THE GREEN CONNECTION

23 March 2024

COMMENTS ON THE DRAFT INTEGRATED RESOURCE PLAN 2023

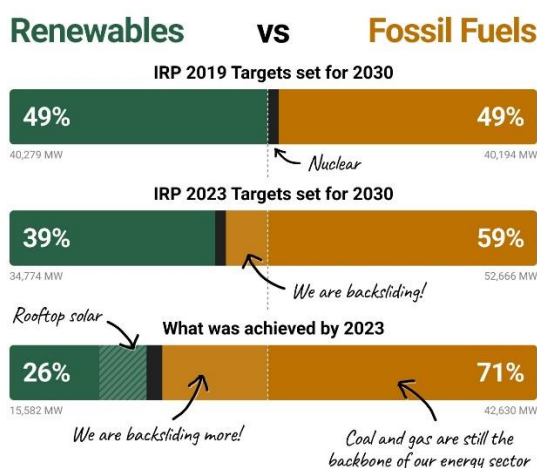
The interventions are business as usual and fail to take into account the reality of climate change, people's health or other externalities.

The graphics inserted here were created to show how the IRP 2023 is actually worse for reducing climate change that the irp2019 and that we are going backwards.

2030 plans vs 2023 reality

In 2019, the IRP put forward plans that acknowledged the need for South Africa to invest in renewable electricity and lower our reliance on fossil fuels by 2030. In 2023, the amount of renewables in our electricity mix was still well behind our 2030 target, and the Department of Minerals and Energy (DMRE) backslid on their planned commitments to renewables.

We would urge the DMRE to examine their assumptions and update their research in order to ensure that the IRP becomes business unusual.
